CITY OF PORT WENTWORTH

PLANNING COMMISSION

MAY 10, 2021

Re: Site Development Plan
Home 2 Suites TDB Magellan Boulevard
Port Wentworth, Georgia

SHEET
 2 OF 25

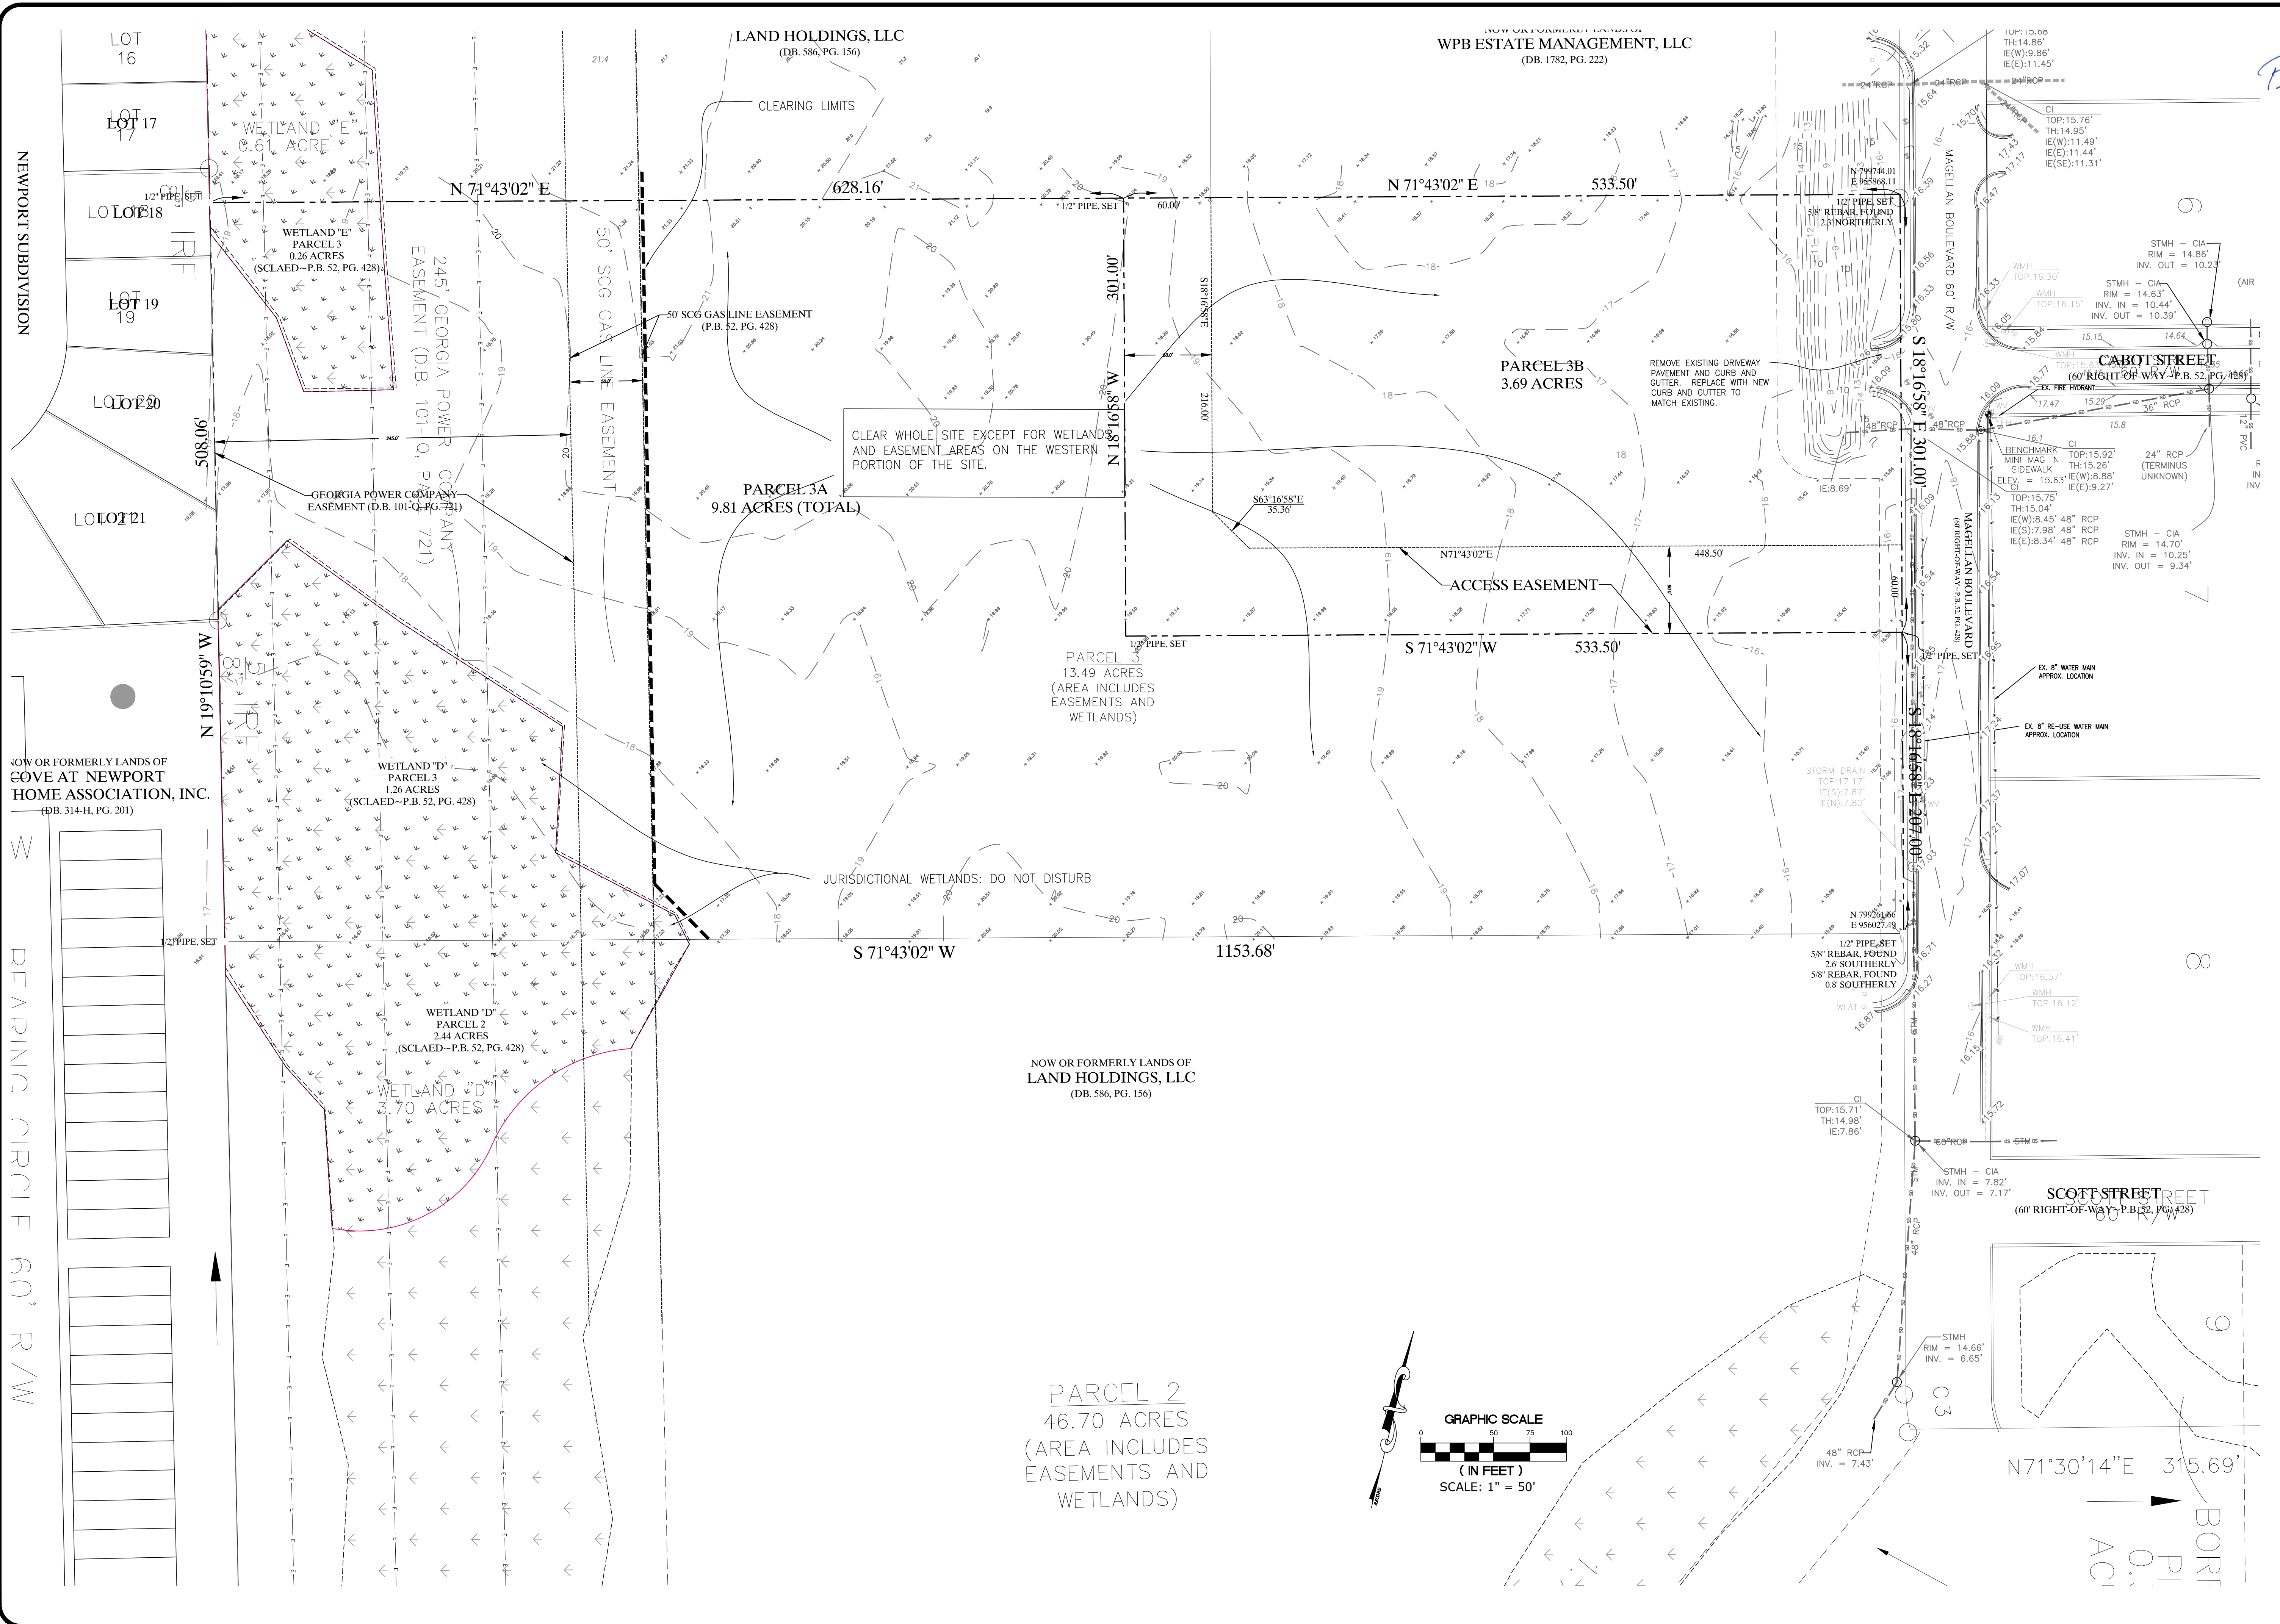
3. On sheet 2, Sewer Note # 7, please update the note to match the City of Port Wentworth specification that the height of manhole is to be 3" above ground in unpaved areas.

4. On sheet 2, Water Note # 5, please update the note to match the City of Port Wentworth specification on 2" and smaller piping. See Specification 02510 section 2.01 E & F. in the City of Port Wentworth Comprehensive Development Manual.

5. On sheet 2, Water Note # 6, please update printed identification to read "Caution Water Line Buried Below" per Specification 02510 section 3.06 B.
6. On sheet 2, Water Note # 7, please update the height above finish grade to comply with the City of Port Wentworth Technical Detail W-9 which shows the height to be 1'-6" to the center line of the pump connection.

7. On sheet 2, Roads and Drainage Note # 6, please update the note to refer to the City of Port Wentworth requirements and not Bulloch County.
8. On sheet 2, Roads and Drainage Note # 7, please add to required presence the City of Port Wentworth Facility Inspector needs to be present for all proof rolls.

SHEET
5 OF 25

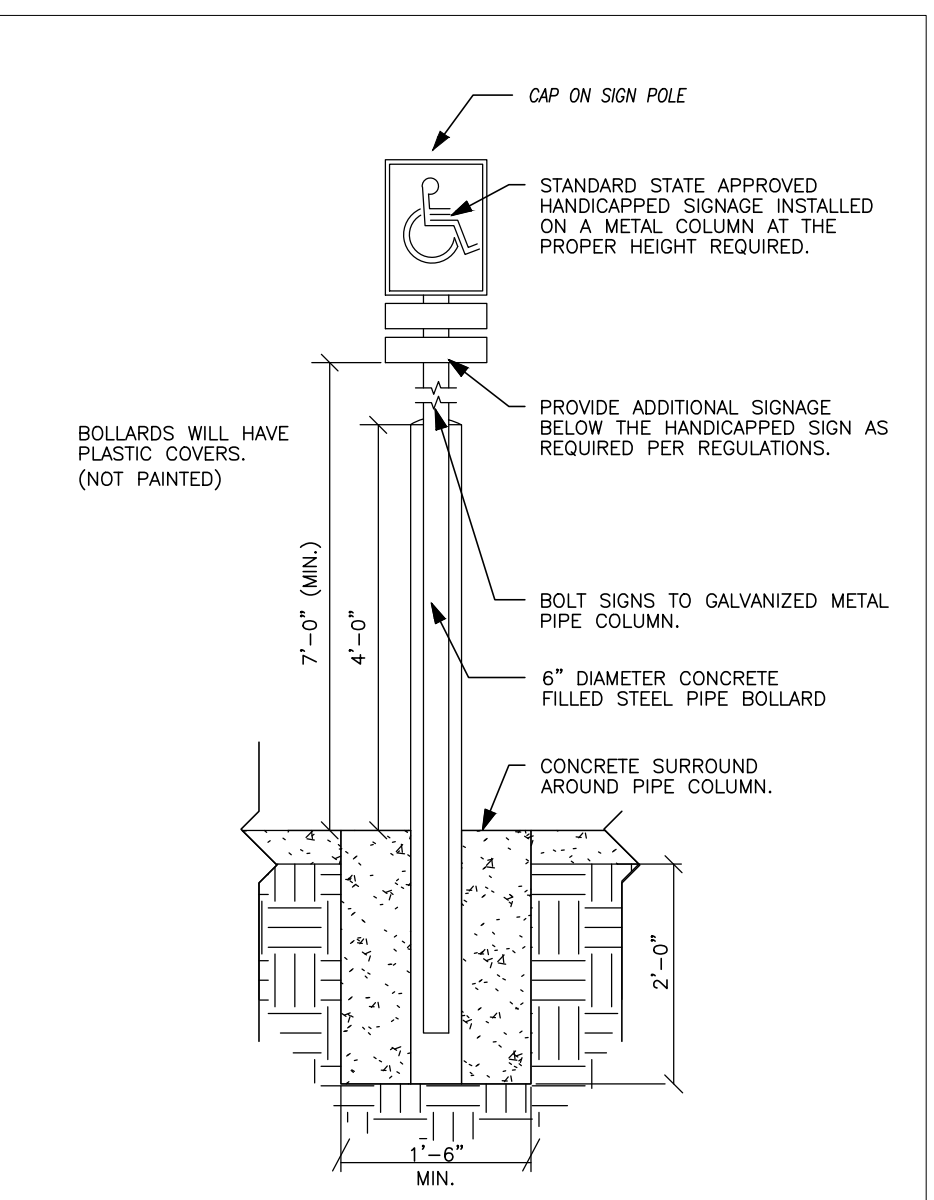
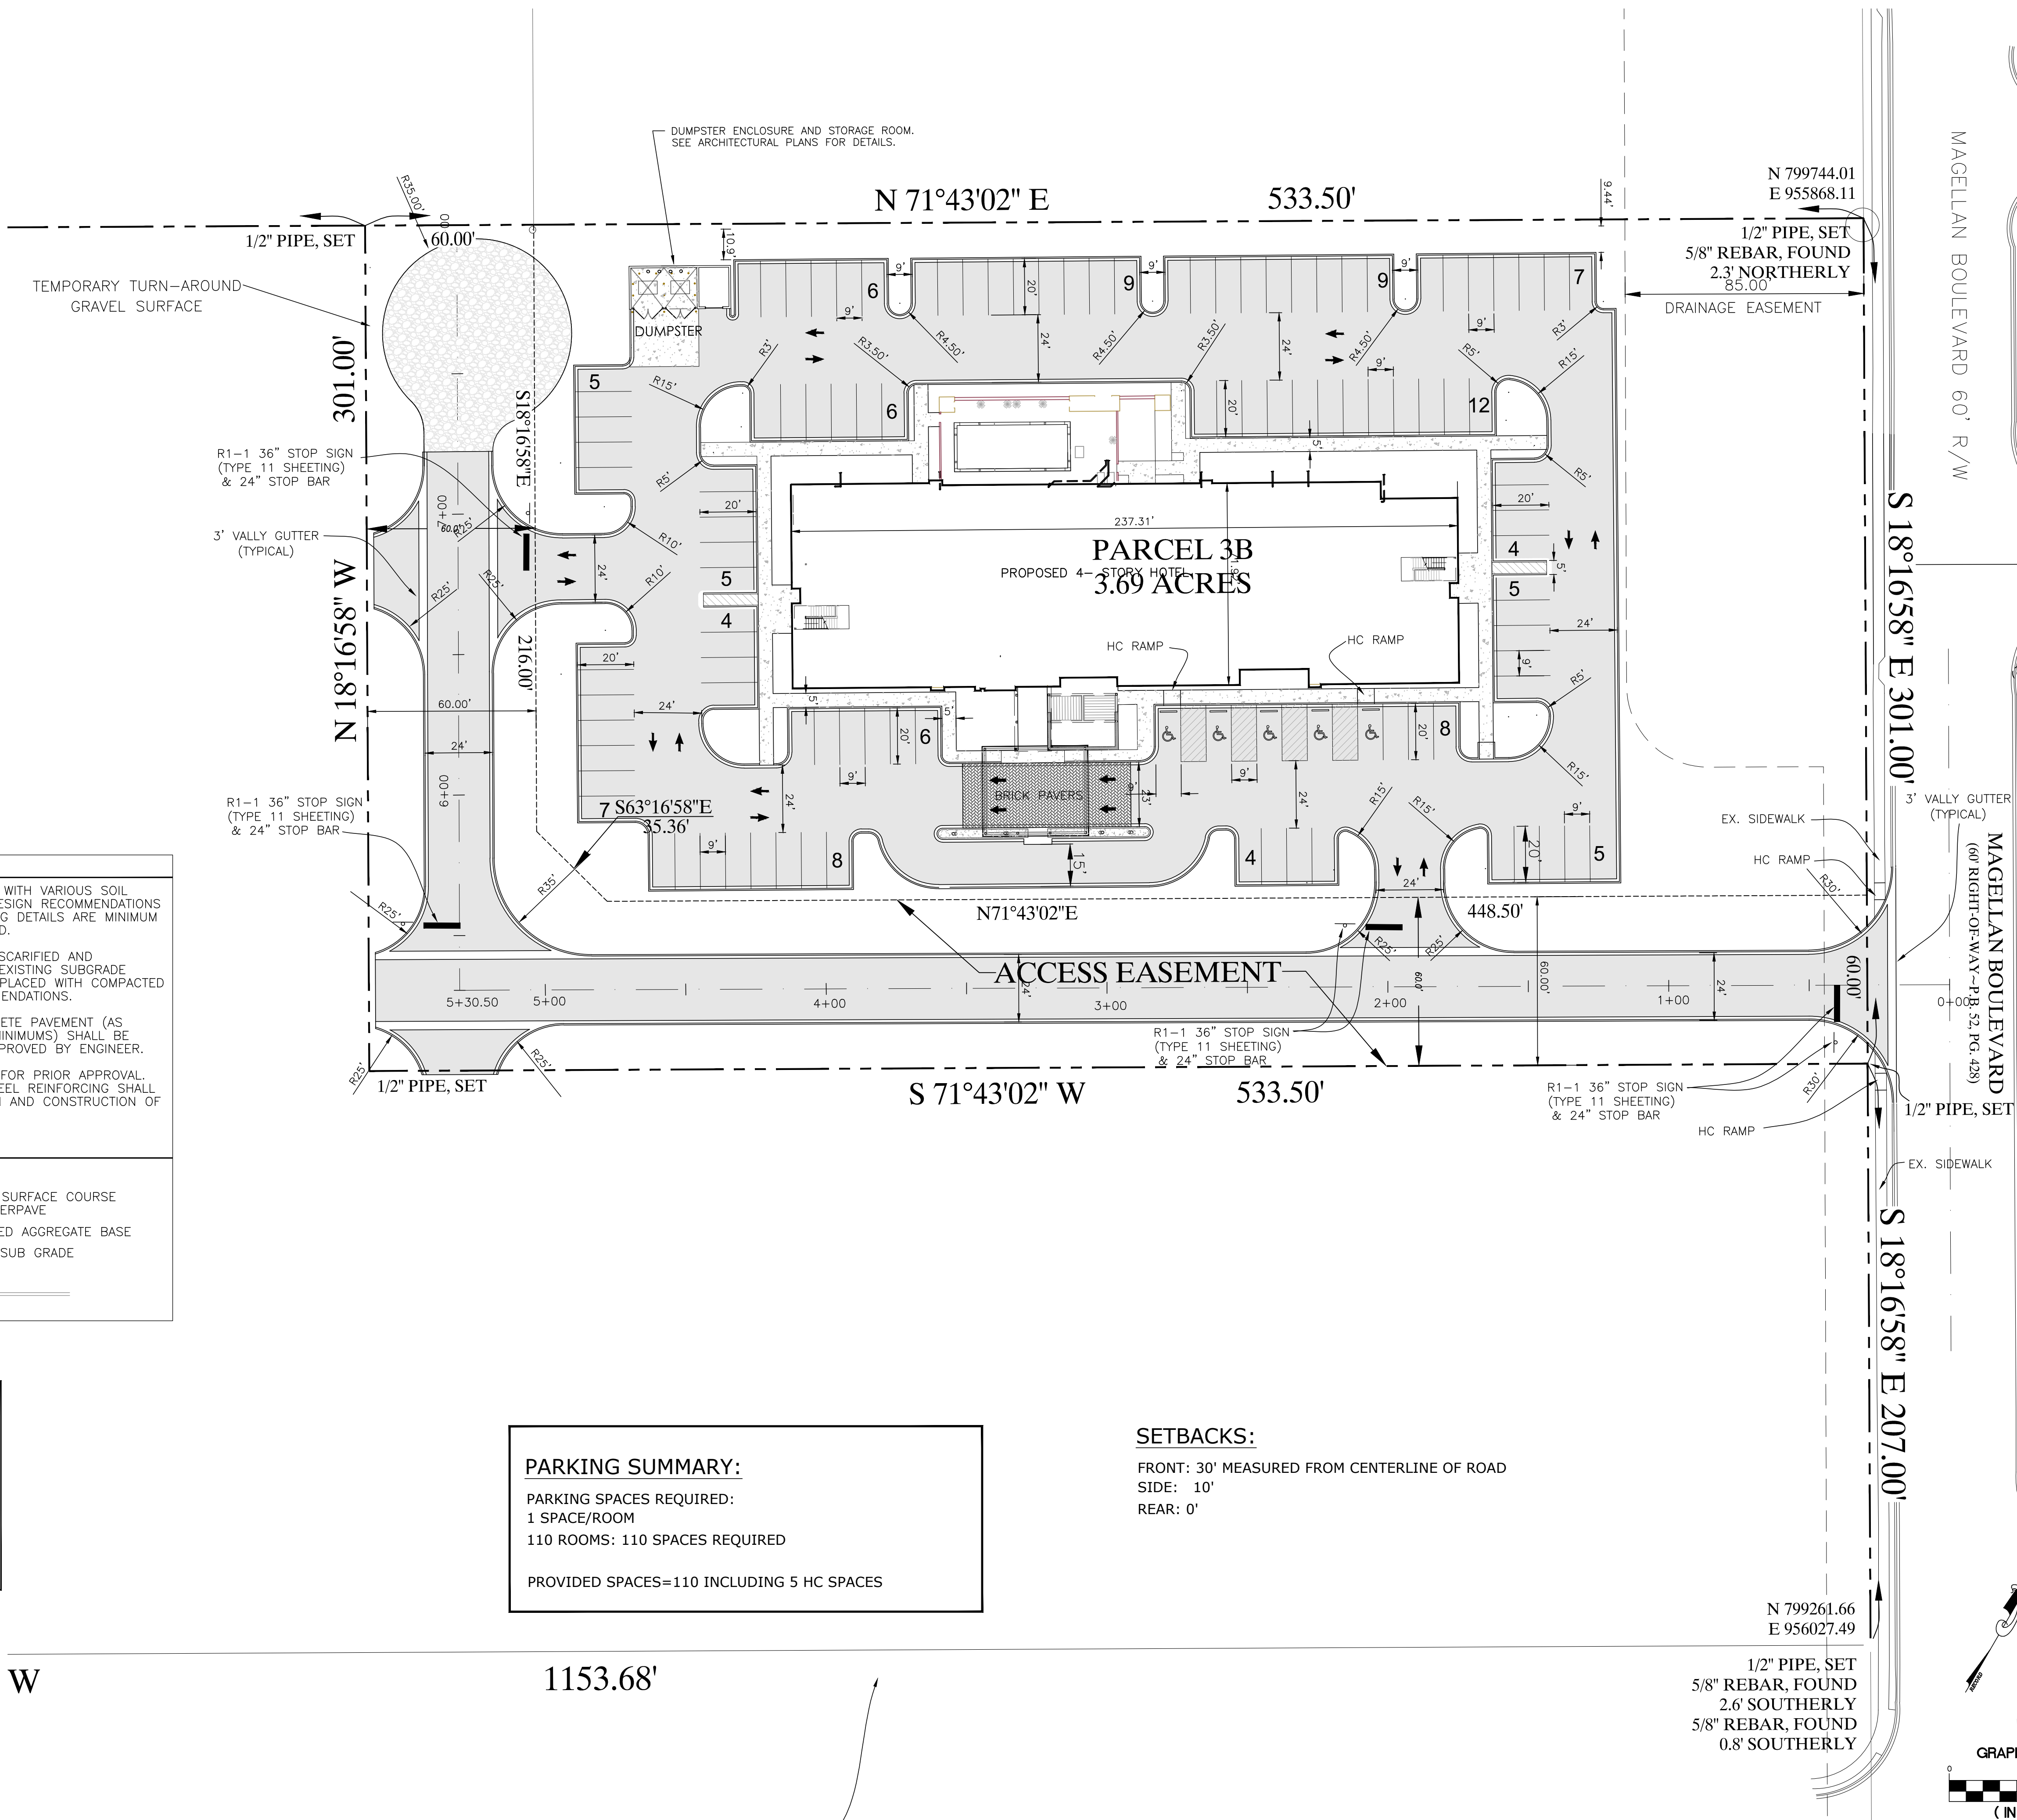
9. On sheet 3, please add the adjacent property owners and property pin numbers to the drawing.
10. On sheet 5, the standard asphalt detail shows 6" GAB. The City of Port Wentworth requires the base course to be 8" of GAB. Reference the City of Port Wentworth Comprehensive Development Manual.
